CROW BUTTE URANIUM PROJECT

Application and Supporting Environmental Report for State of Nebraska Underground Injection Control Program Commercial Permit

ERRATA SHEET

ERRATA SHEET DEC Completeness Review

REV.	FERRET OF NEBRASKA, INC.		
DATE			
	CROW BUTTE PROJECT		
	Dawes County, Nebraska		
	ENGLISH CREEK AND		
	SQUAW CREEK WATERCOURSES		
	PREPARED BY: F.E.N.		
	DWN. BY: JC	DATE: 8/87	FIGURE: 4.4-1

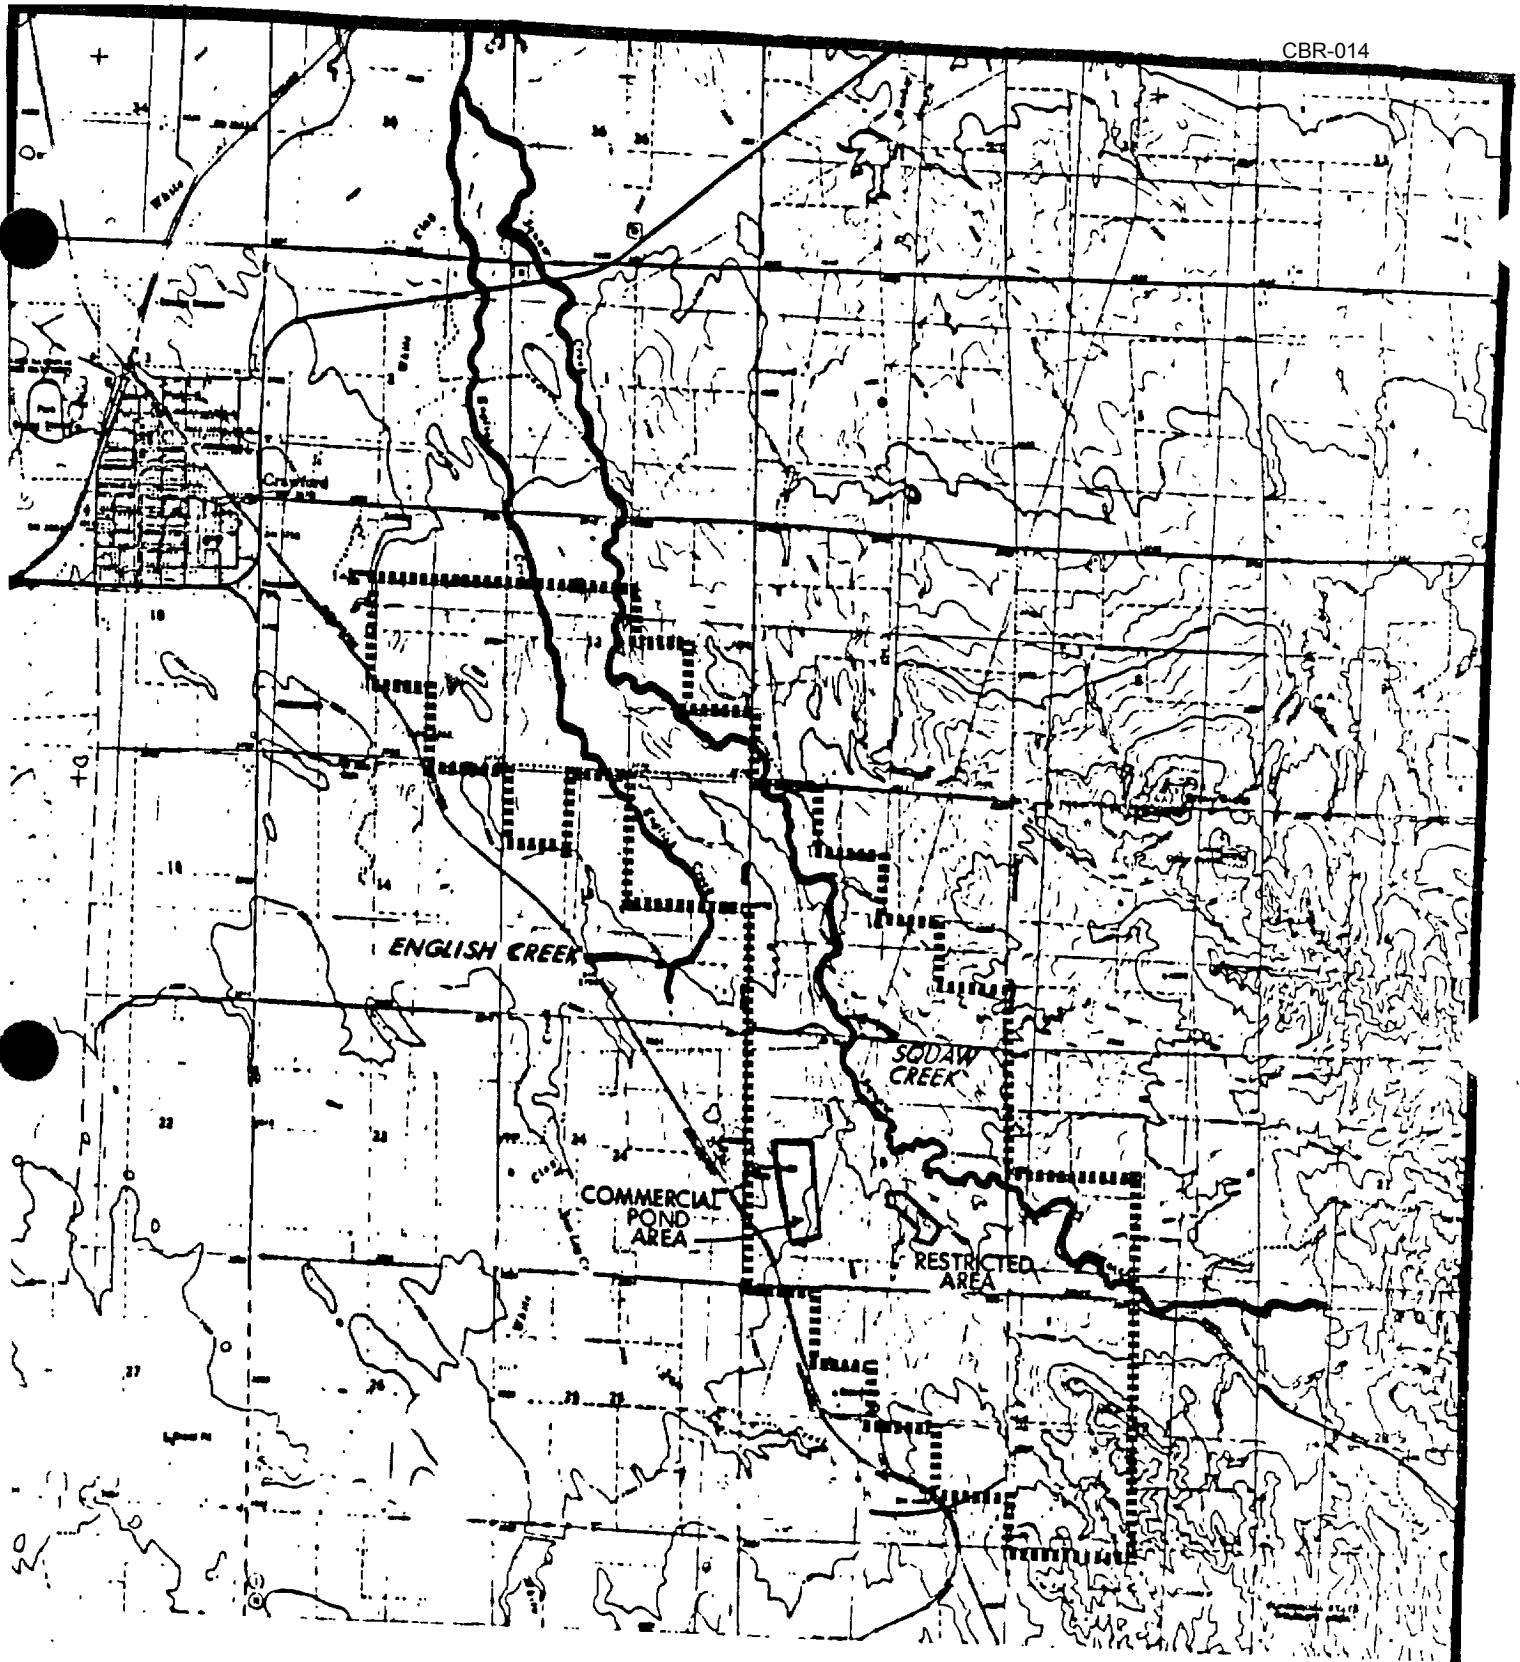
1. The following permits or construction letters must be added on Page 1 of the introduction:
Class V 5W-11
Septic Tank
Pond Permit
Water Resources Permit
2. Page 4.4(3); Figure 4.4-1, no scale.
3. Page 4.4(14); toward is misspelled.
4. Page 4.4(16); Figure 4.4-7, no scale.
5. Page 4.5(22); typing error; should read "the".
6. Page 4.5(25); P. 3 L4-5, are there some words missing?
7. Page 4.7(15); local economy has misplaced comma.
8. Page 4.8(3); L2-3 should read "published" instead of "publisted?"
9. Page 4.8(53); P.2 L1 featire number is missing.

| PSF | <ol style="list-style-type: none"> 1. Correction page 3.0(1) attached and page 1 of Introduction 2. Corrected Figure 4.4-1 attached 3.* Corrected page 4.4(14) attached 4. Corrected Figure 4.4-7 attached 5. Section 4.5 replaced 6. Section 4.5 replaced 7.* Corrected page 4.7(15) attached 8.* Corrected page 4.8(3) attached 9. Corrected page 4.8(53) attached 10. FEN response 11. Corrected page 5.0(6) attached 12. Corrected page 5.0(10) attached 13. FEN submitted NRC Attachment A 14. Section 4.8 Appendices A and B provided 15. Section 4.5 replaced 16. See page 4.6(3) and page 1 of Introduction |

REV	DATE	FERRET OF NEBRASKA, INC.
02/16/88		CROW BUTTE PROJECT
		Dawes County, Nebraska
		EARTHQUAKE EPICENTERS
		IN NEBRASKA
		PREPARED BY: F.E.N.
	OWN BY: J.C.	DATE: 8/87
		FIGURE 4.5-15

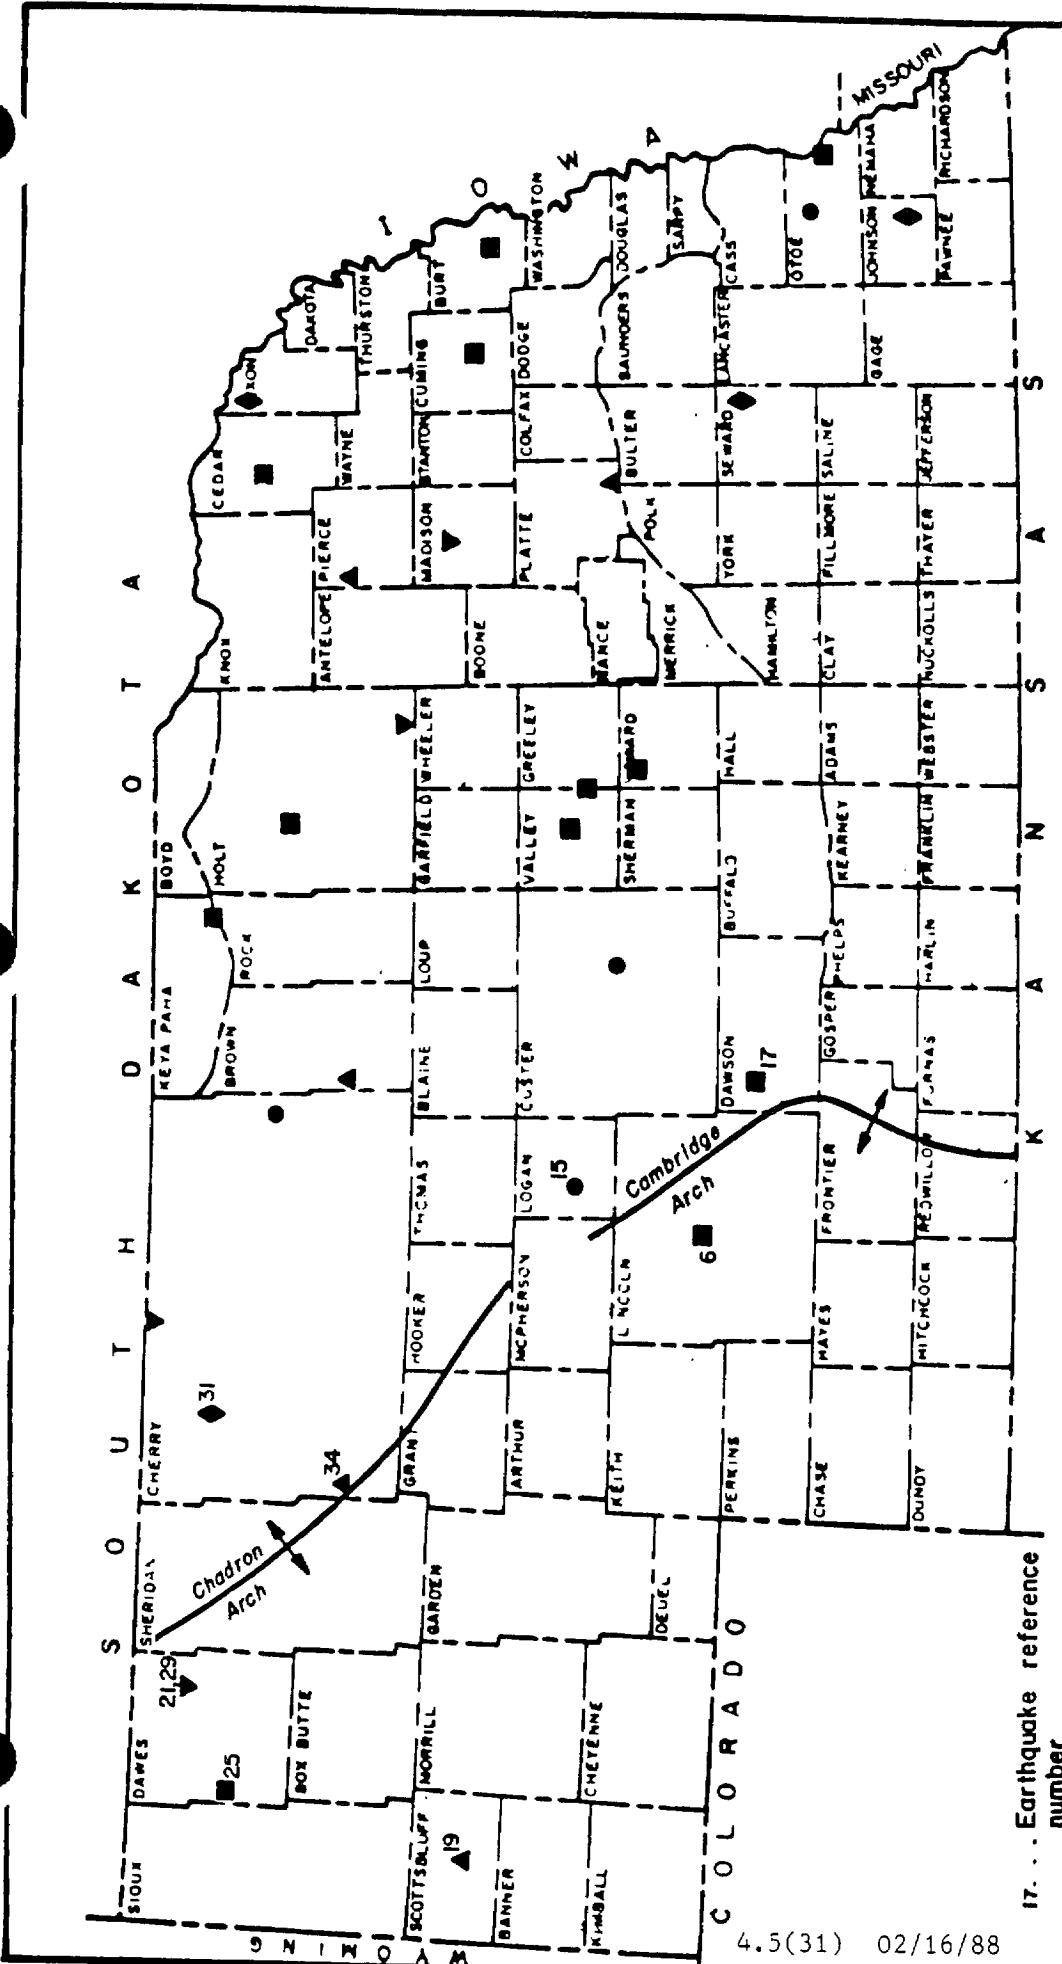
| JA | <ol style="list-style-type: none"> 1. Figures 4.2-1 replaced earlier; Figures 4.4-1 and 4.4-7 replaced by PSF #2 and PSF #4; Corrected Figure 4.5-15 attached 2. FEN response 3. Corrected page 4.4(50) attached and Appendix 4.4(C) 4. FEN response 5. Corrected page 4.4(56) and 4.4(56A) attached. |

REV. DATE	FERRET OF NEBRASKA, INC.		
	CROW BUTTE PROJECT		
	Dawes County, Nebraska		
	PROPOSED MINE SCHEDULE		
	YEARS 1-10		
	PREPARED BY: F.E.N.		
	DWN. BY: J.C.	DATE: 8/3/87	FIGURE 5.1-1

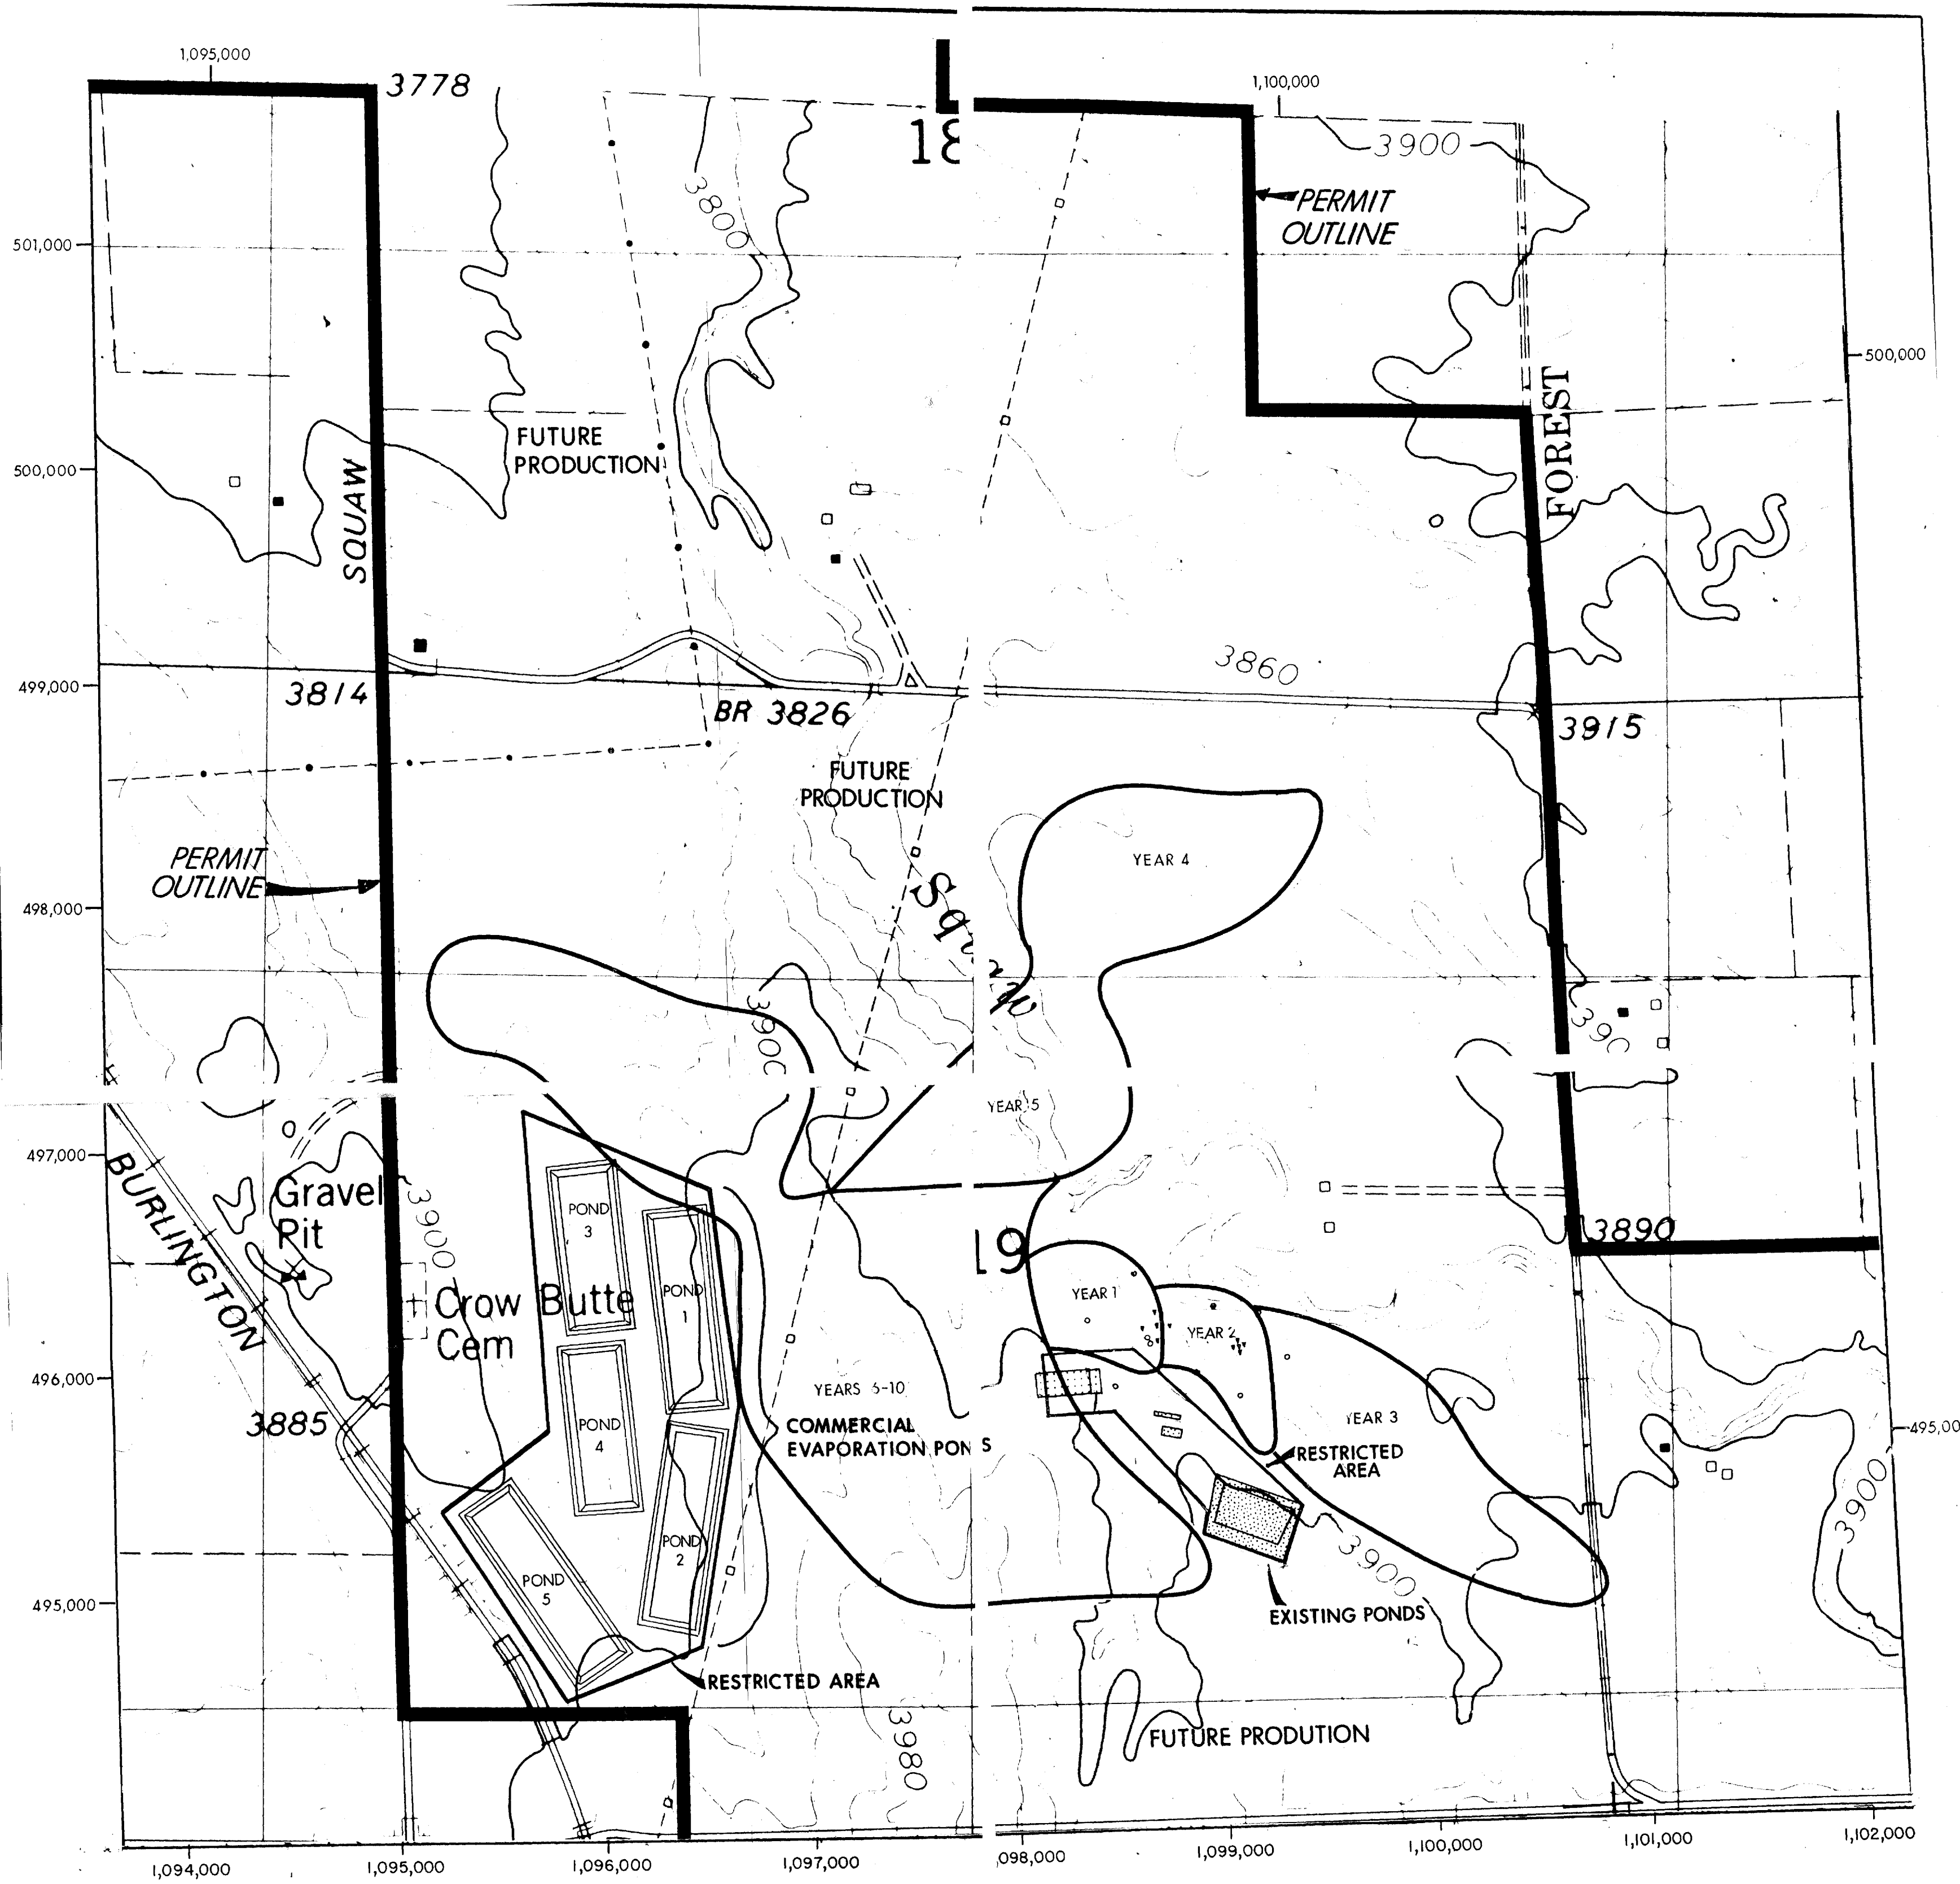
- 5.0(1) Revised second paragraph under 5.1-1, Wellfield Operation
- 10.0(1) Revised paragraph under 10.1, Surface and Subsurface Injection System
Details
- 10.0(2) Revised Figure 10.1-1
- 12.0(8) Revised first paragraph under 12.4-3, Wellfield Surface Monitoring
